A d d e n d u m

Iowa Department of Transportation
Office of Contracts

B.O.	Proposal ID	Proposal Work Type	County	Project Number	Addendum
010	43-1912-007	BRIDGE REPLACEMENT - CCS	HARRISON	BRFN-191-2(7)--39-43	18FEB010.A04

FLOATING SILT CURTAIN

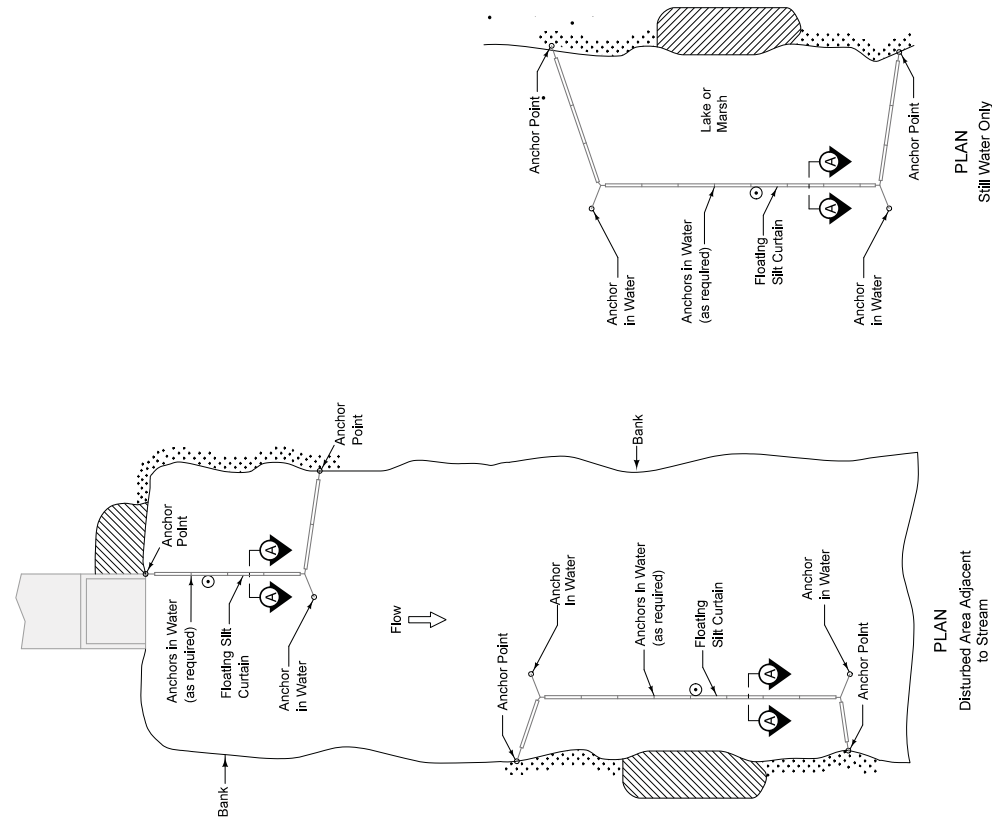
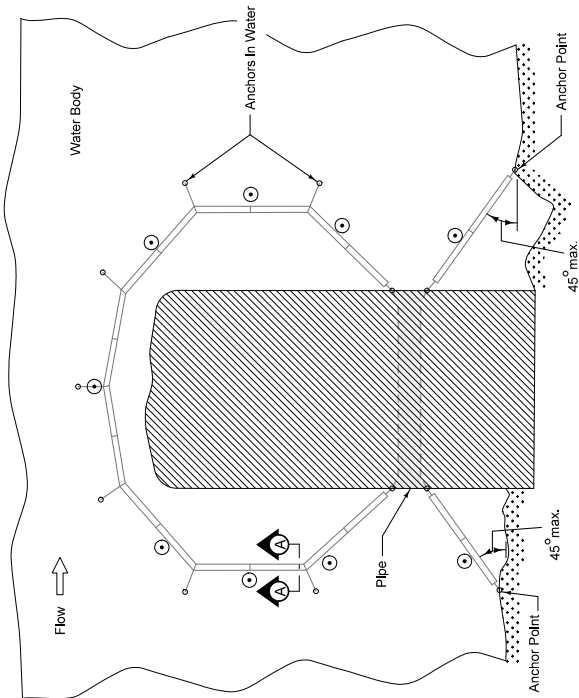
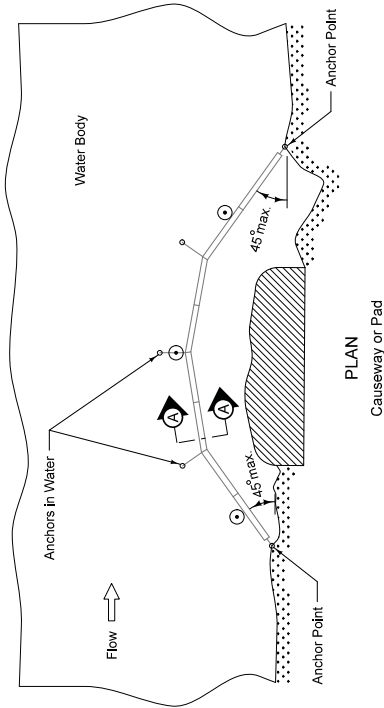
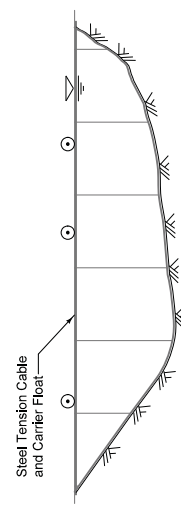
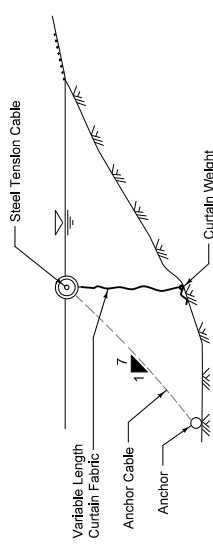
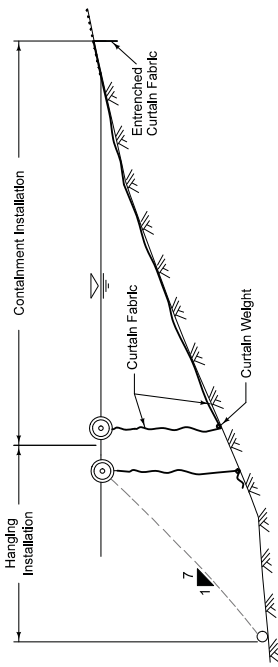
REVISIONS: Removed 100' typical spacing between anchors on page 2. Added possible contract item. Removed sections of standard notes and title note 1.
